Subject: <p style="text-align: center;">MULTIPLE ELECTRICAL MALFUNCTIONS AFTER BODY REPAIR</p>	<p>Service Alert No.: SA-010/23</p> <hr/> <p>Last Issued : 02/09/2023</p>
---	---

This bulletin supersedes the previously issued bulletin(s) listed below: The changes are noted below in red.

CX-5 shown

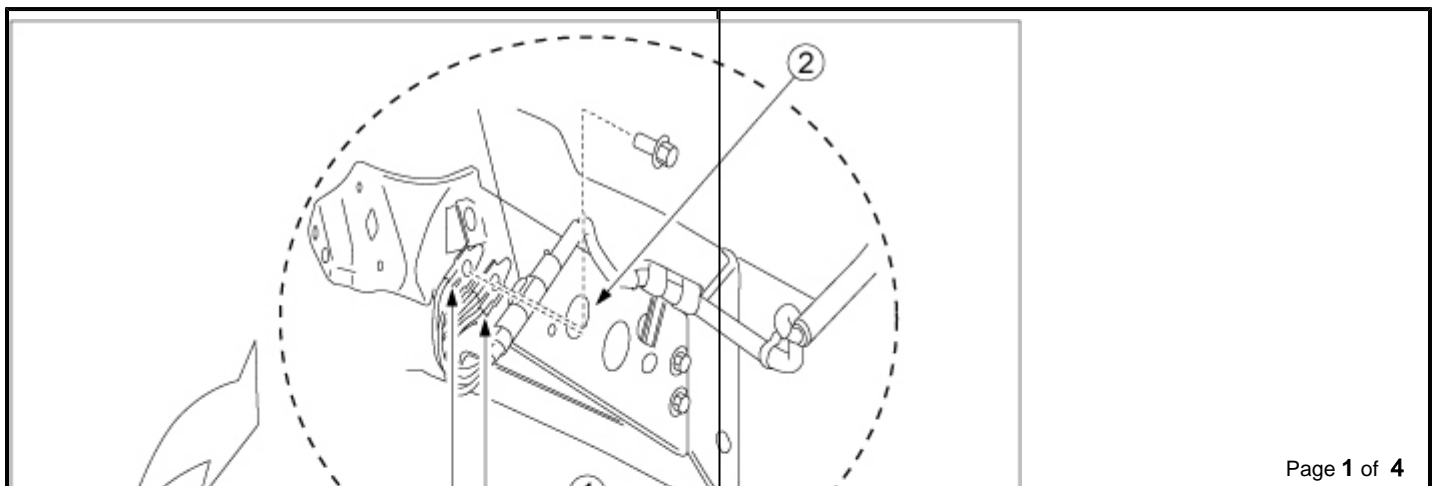
Some customers may experience one or more electrical malfunctions after a vehicle body repair. The newly painted fender stay (2) may be causing a poor front harness (1) ground connection.

CX-5 shown

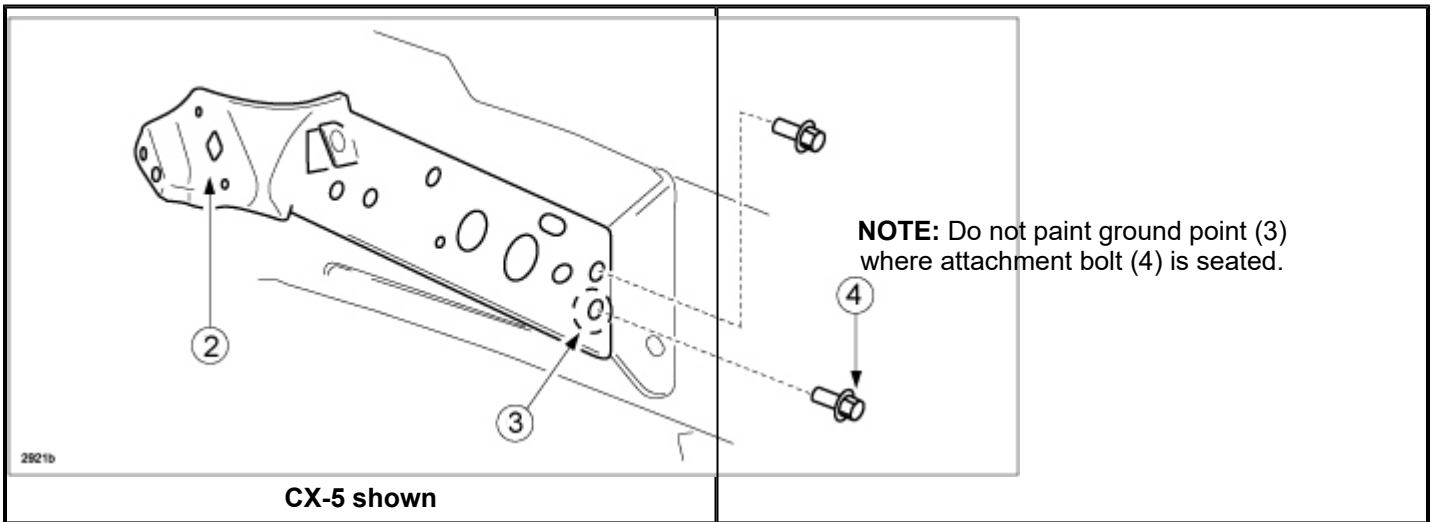
The front fender stay (2) newly painted surface at ground point (3), where attachment bolt (4) is seated, may create a poor front harness ground connection.

CAUTION: If the bolt (4) contact area (3) is painted when the front fender stay (2) is newly replaced, it could cause a malfunction in the PCM. Before painting a newly replaced part, protect the bolt (4) contact area (3) with masking tape (5) as shown in the figure.

Customers concern can be resolved by sanding off paint at ground point (3) where attachment bolt (4) is seated. After installing the bolt (4), apply touch-up paint to the exposed base material area of the front fender stay.

NOTE: After installing the bolt (4), apply touch-up paint to the exposed base material area of the front fender stay.

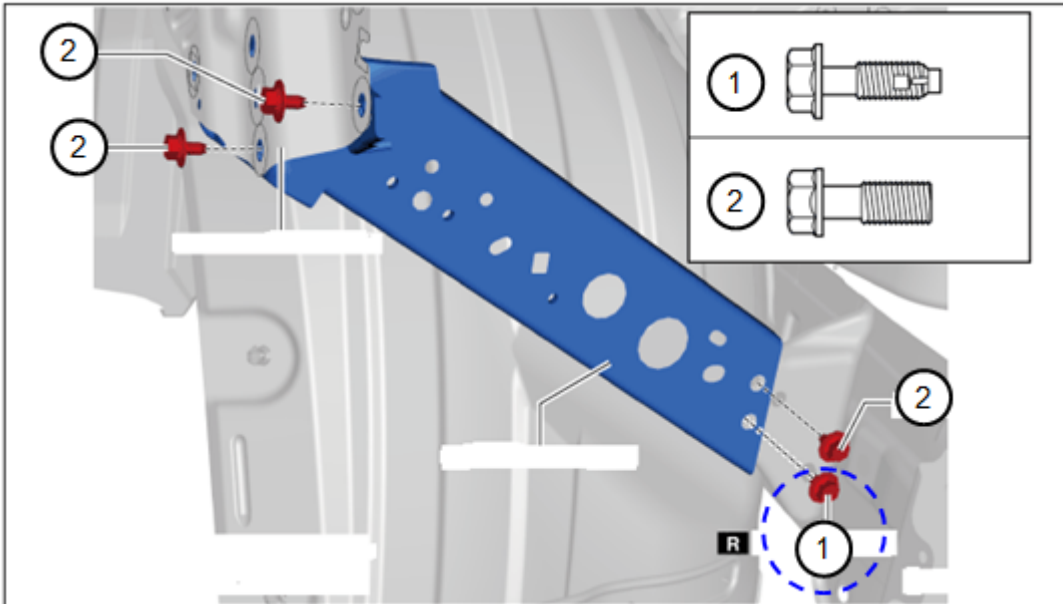
NOTE: Always replace the ground bolt (1) if the Workshop Manual or Bodyshop Manual instructs to use the ground bolt for proper grounding.
